STAFF REPORT

June 16, 2015

- RE:**
- a) **Case 10390-URD-10**
 - b) **Case 10390-MPD-11**
 - c) **SD 1176B – Final Plat, Three Trails Commerce Center**
- APPLICANT:** Brent Miles
NPIF2 Three Trials Industrial Park, LLC
5015 NW Canal Street
Riverside, MO 64150

- c) **SD 1176B – Final Plat, Three Trails Commerce Center** - To consider approval of a final plat in District MPD on approximately 57 acres, creating two (2) industrial lots and one (1) tract.

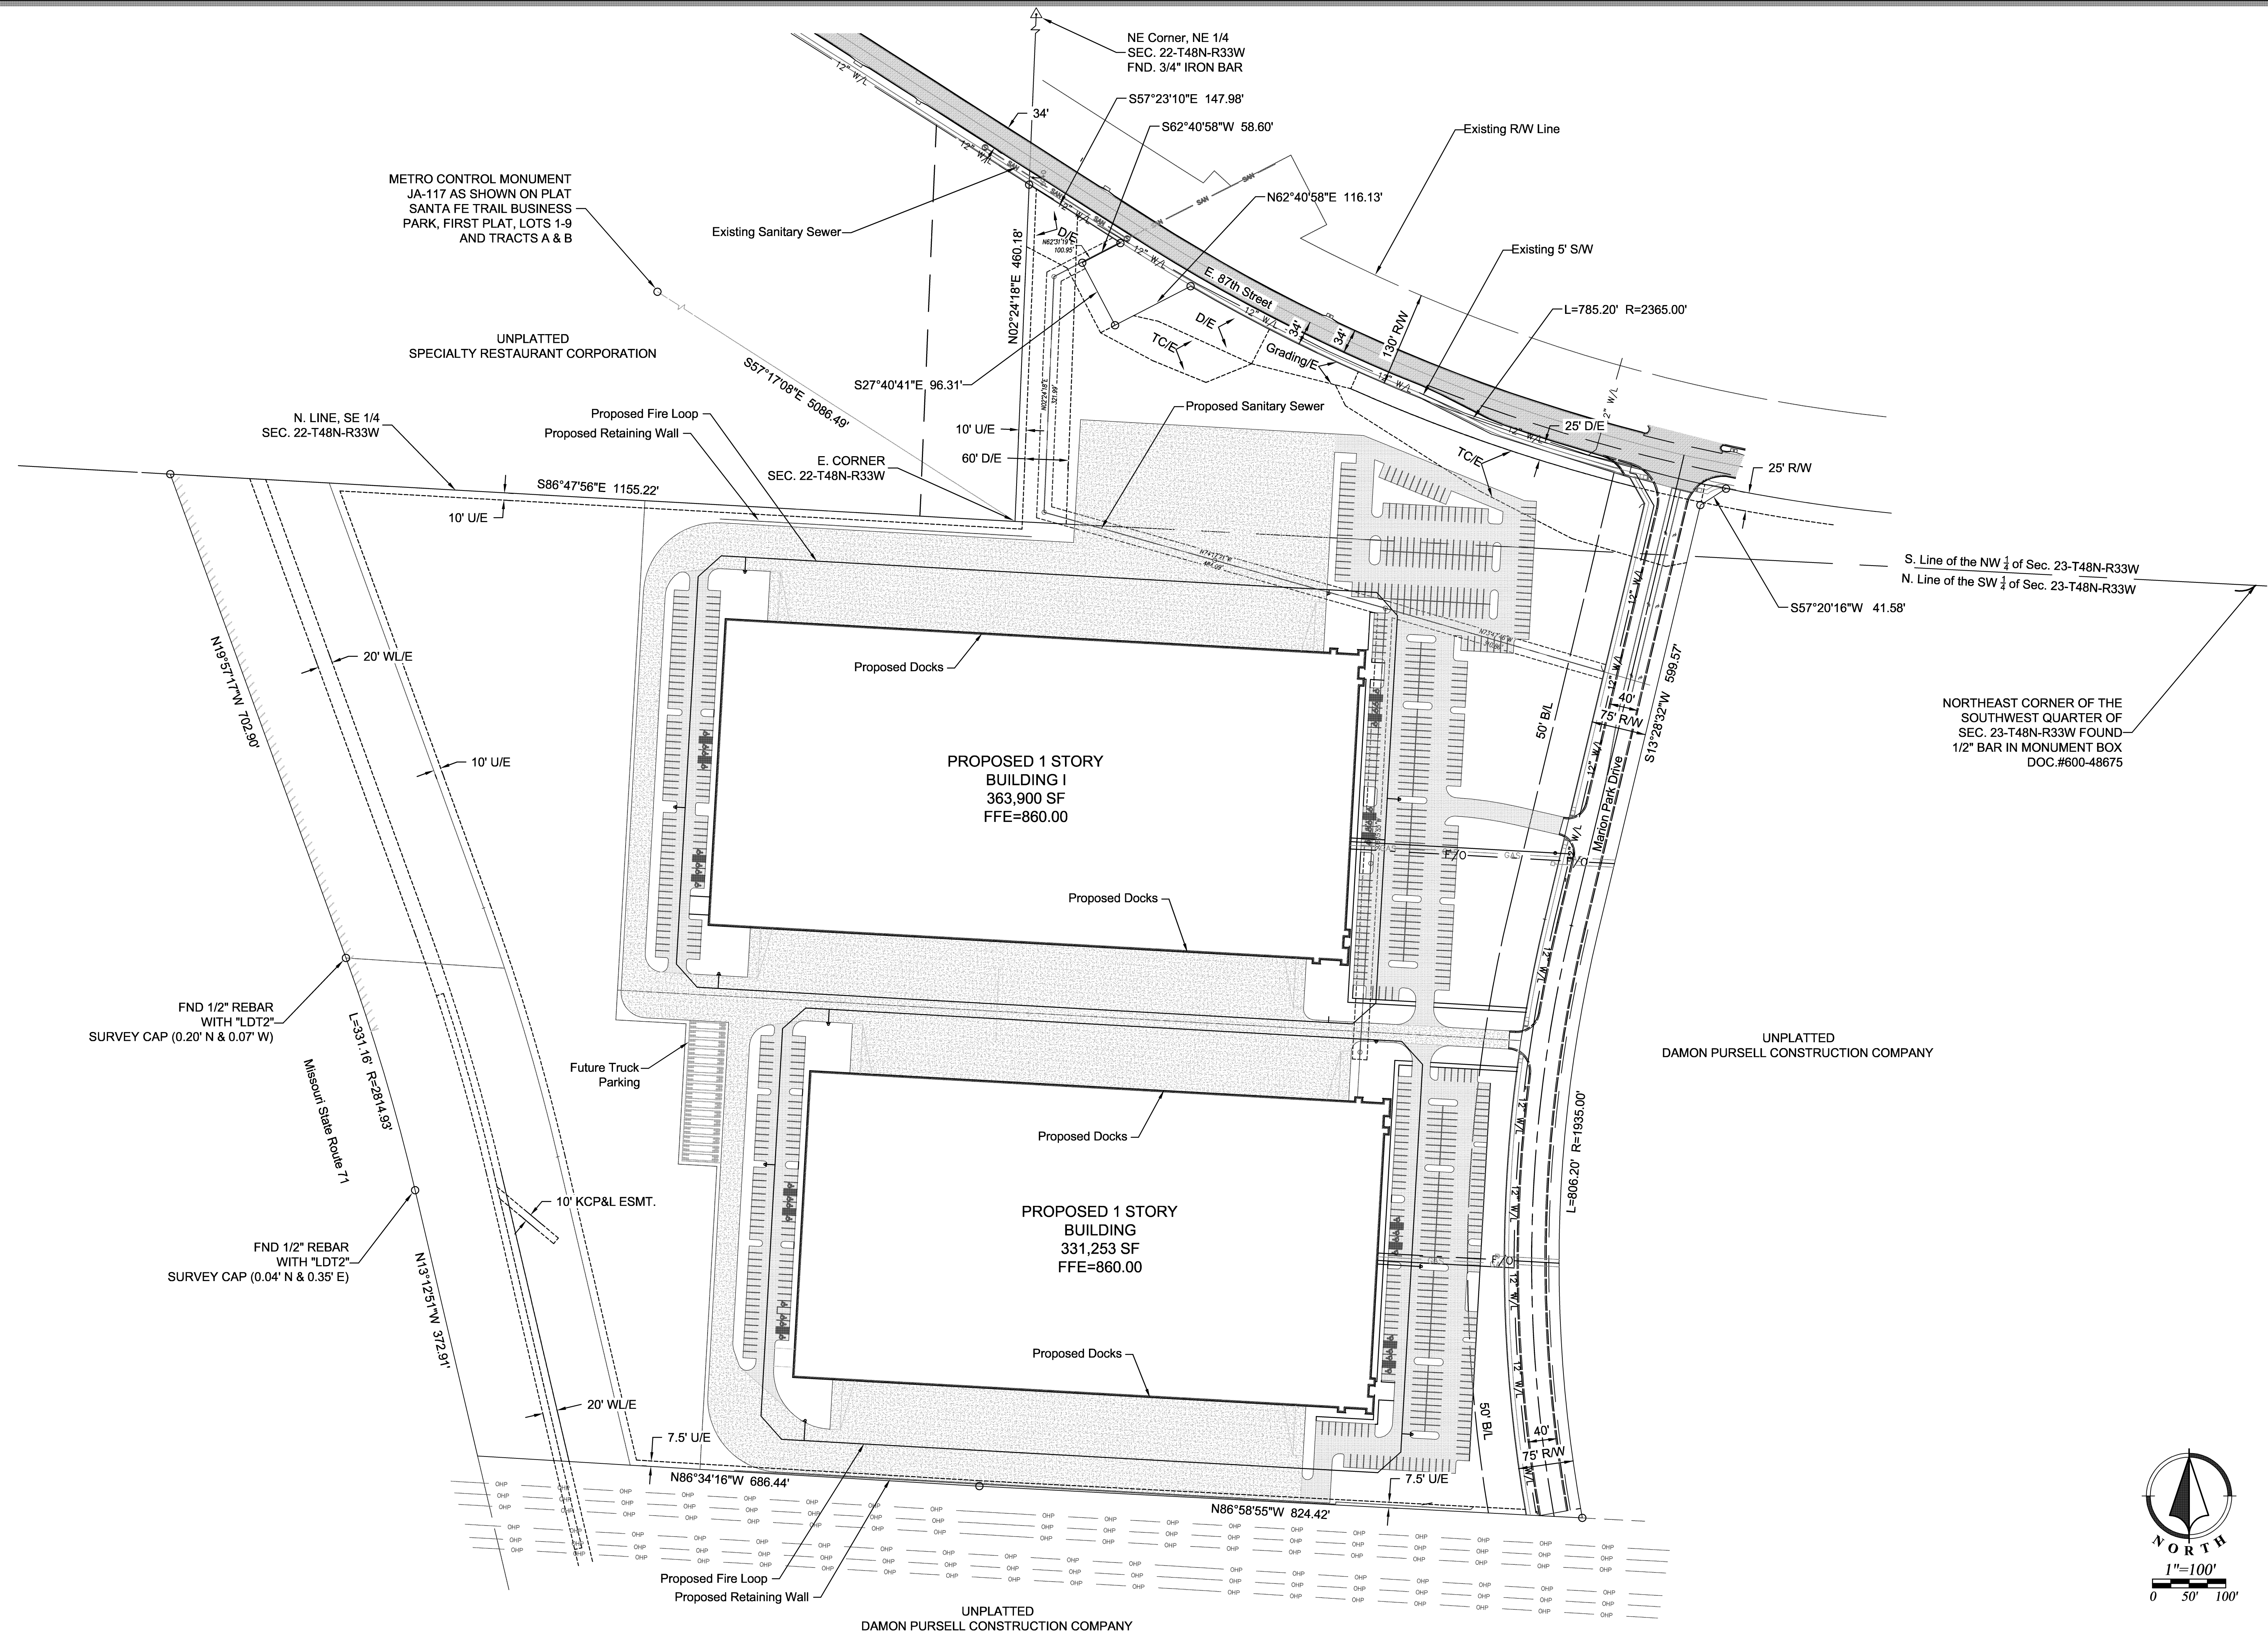
- a. Correct title to read "Three Trials Commerce Center MPD Development Plan".
 - b. Sizes of Lots 1 & 2.
 - c. A lighting plan that meets the requirement of Chapter 88-430 in its entirety.

- d. A signage plan that meets the requirements of Chapter 88-445 in its entirety.
 - e. Staff recommends that the number of tenants on the oversized monument sign be limited to 4 tenants (2 per building/ lot).

- f. A revise plan that meets the requirements of Chapter 88-420 as it relates to short and long term bicycle parking.
 - g. Temporary cul-de-sac at the terminus of Marion Park Drive.

- h. Provide a typical section for Marion Park Drive.
 - i. Show proposed storm sewer along Marion Park Drive.
 - j. Storm Study Comments:
 1. Provide an analysis of the watershed to the point where the proposed project is 10% of the overall watershed per APWA 5601.5.A.4.

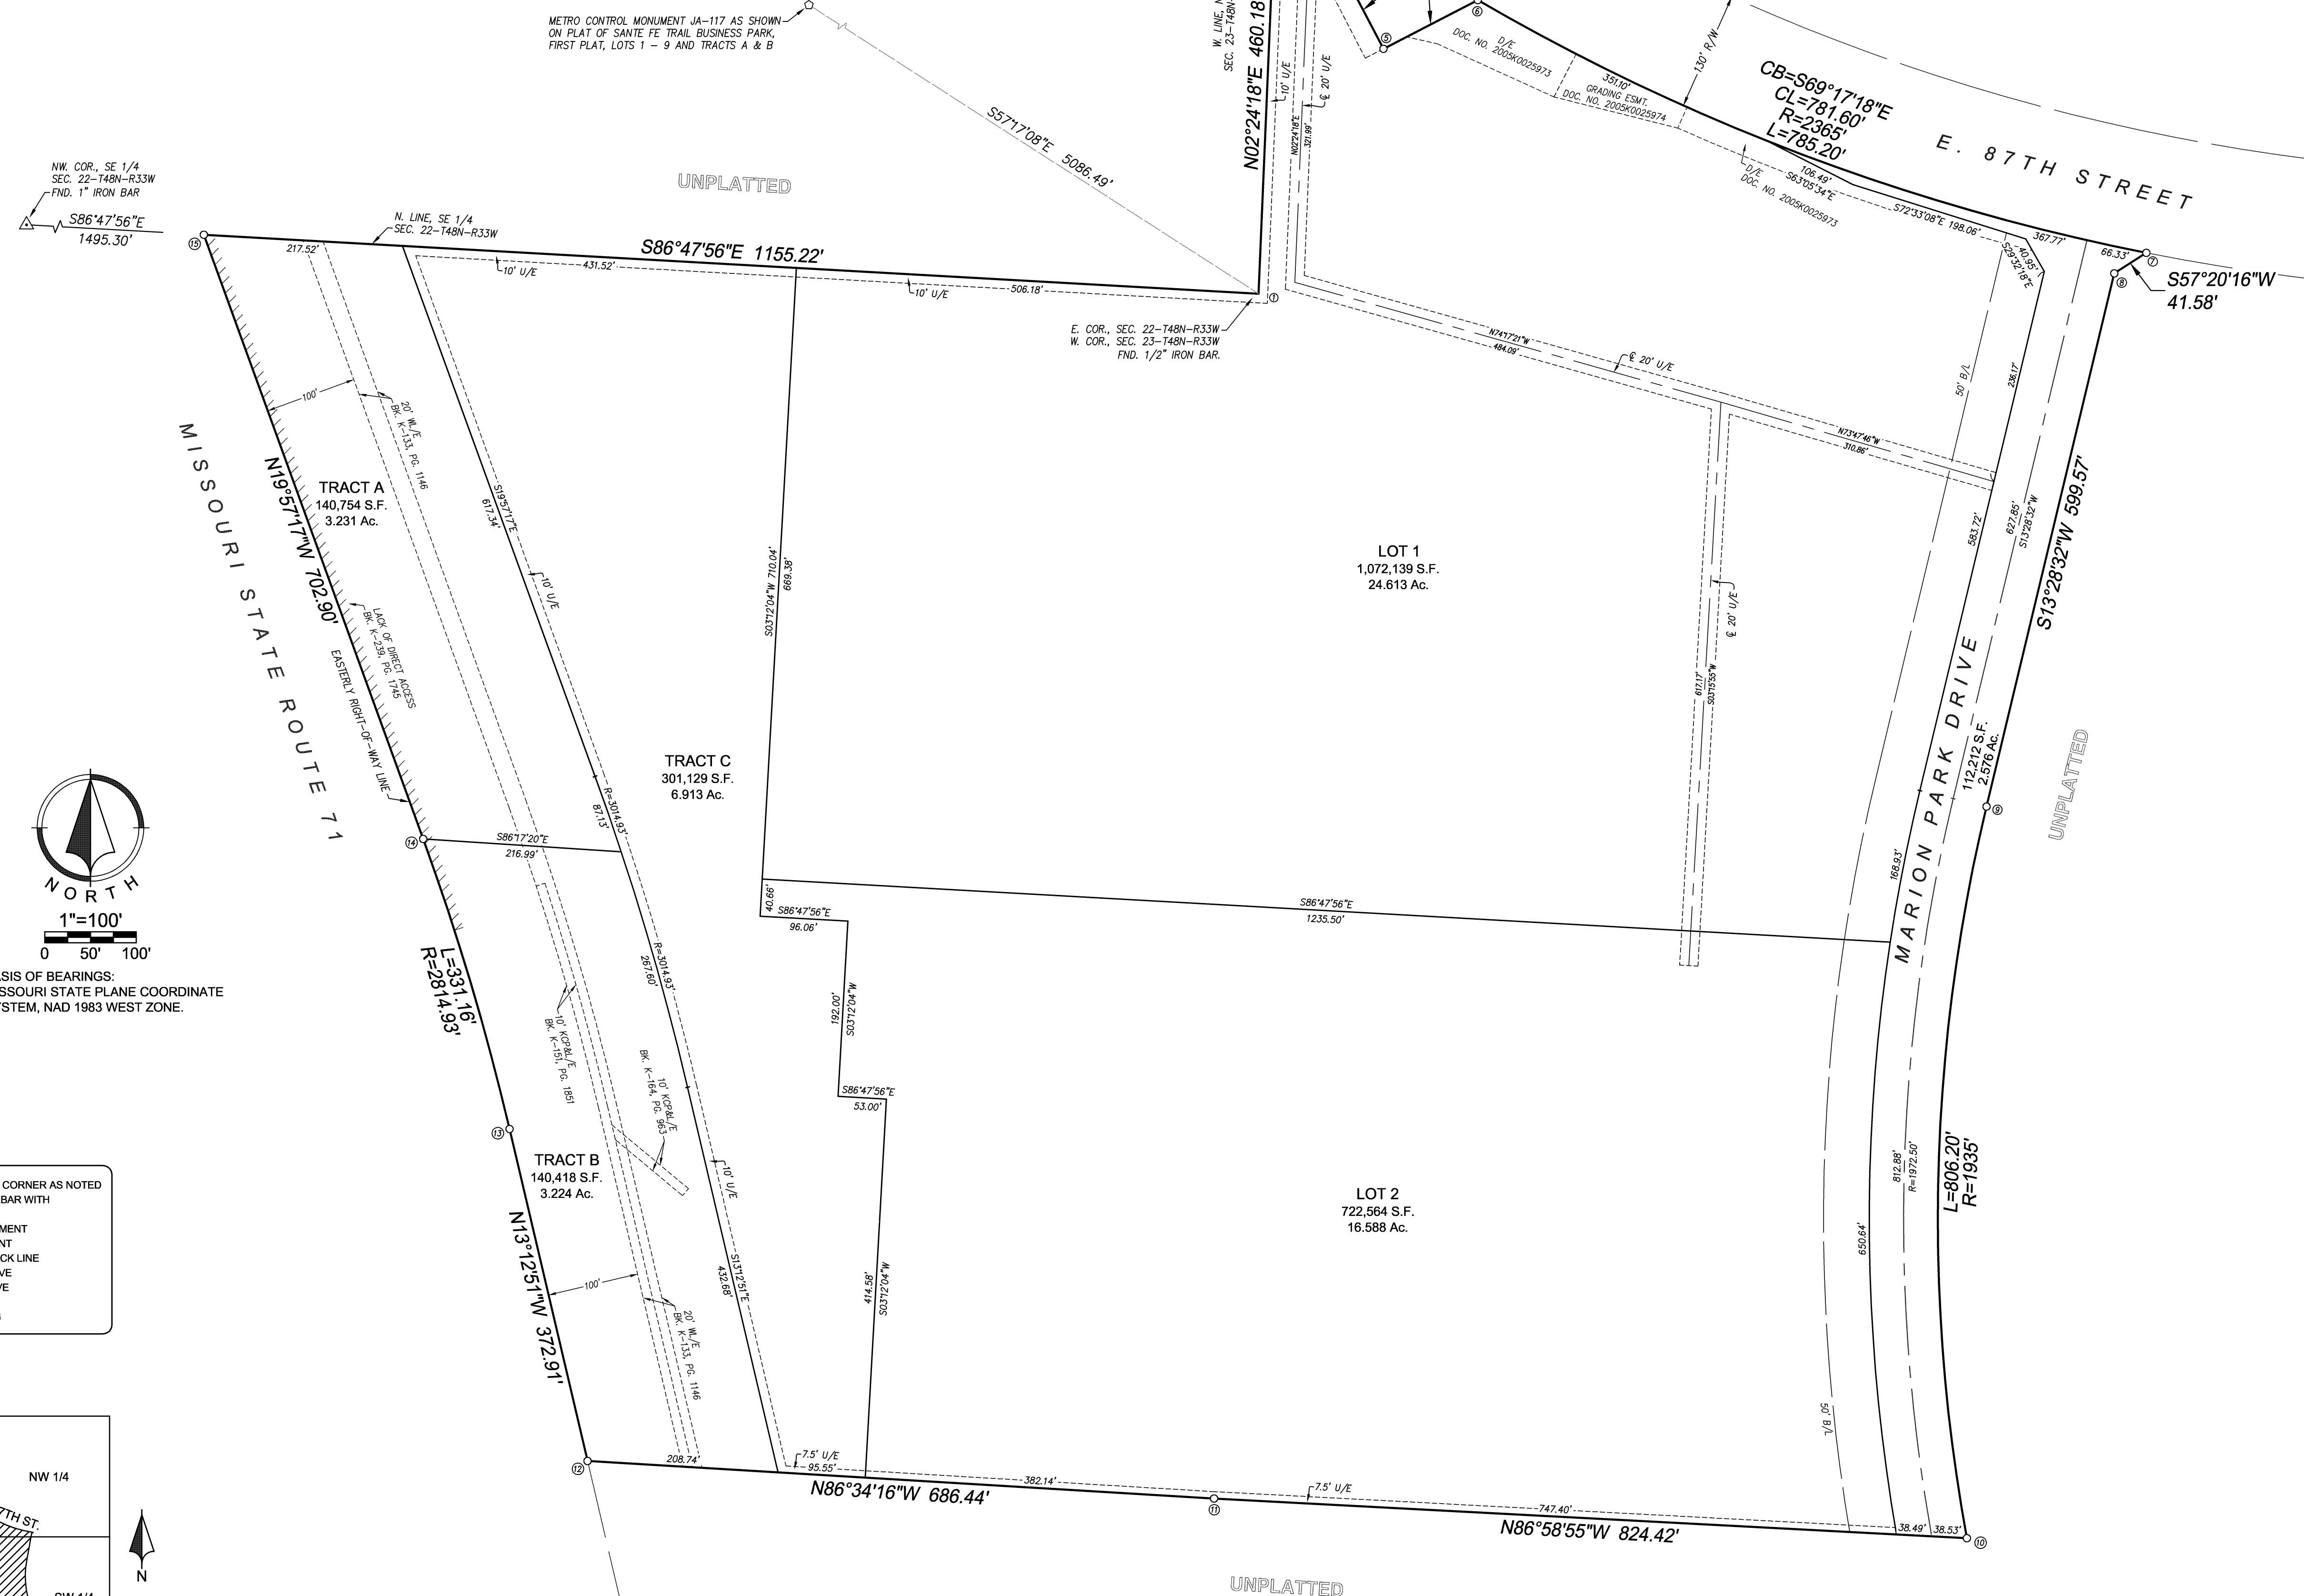
1. That the plat be revised to show:
 - a. All corrections identified in the Land Development Division final plat checklist.
 - b. Show existing floodplain on the Plat.

- c. Show Stream Buffer easement or Tract on the Plat.
 - d. Reference the correct name of the recorded plat in the heading. (Santa Fe Trail Business Park...)

- e. Add the name and address of the developer.
 - f. Add the City Plan Commission recommended approval date from the City Plan Commission disposition letter sent to you by the City Planner.

- g. All streets (interior and exterior) previously dedicated as existing right-of-way should reference the ordinance # that established the right-of-way and the date that the ordinance was passed by Council. (This is usually also going to be the same ordinance and date passed for the street grades if they have already been established.)

- h. Add a the note for any right-of-way being vacated by this plat to read, 'To Be Vacated By This Plat' and state if utility rights are being retained.

- i. Use leader lines to show the limits of the right-of-way being vacated by this plat.
